# Recall Campaign

December 2011  
FL609A  
NHTSA #11V-330  
Transport Canada #11-236

## Copy of Notice to Owners Subject: Starter Cable Isolator Bolts

### Subject: Starter Cable Isolator Bolts

**Fig. 1, Installation that Requires Replacement**

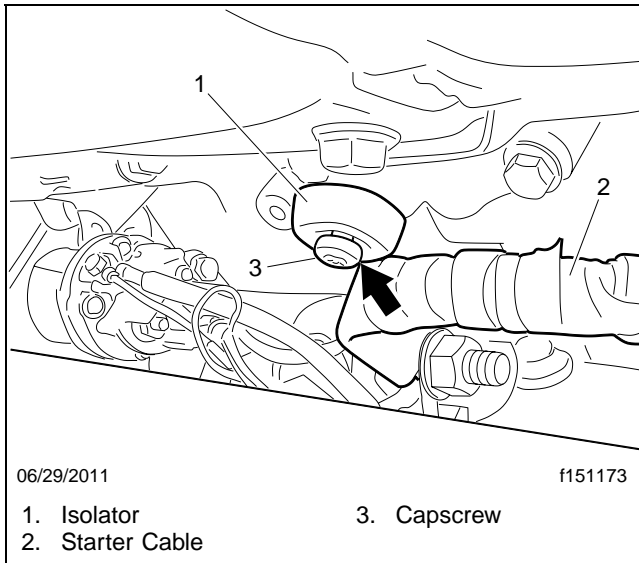
On some vehicles equipped with a Detroit Diesel DD15 or DD16 engine, the bolt attaching a rubber isolator to a support bracket may become loose and back out, potentially contacting an un-fused starter cable and creating a short circuit. A short circuit between an un-fused starter cable and chassis ground could result in a vehicle fire.

4. Remove the capscrew, washer, and isolator from the side of the engine, then discard them. See **Fig. 1**.

**Fig. 2, Installing Isolator with Nylon Push-Rivet**

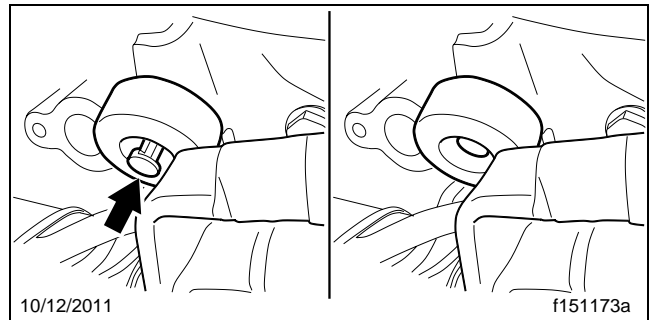
A new rubber isolator will be installed with a push-in rivet. If your vehicle has had an interim repair, it still requires this final remedy.

5. Install the new isolator using the nylon push-rivet from the kit. See **Fig. 2**. There must be approximately 1/2-inch (13 mm) of clearance between the isolator and the starter cable.
6. Connect the batteries.
7. Clean a spot on the base label (Form WAR259) and attach a completion sticker for Recall FL609 (Form WAR260) to the base label.
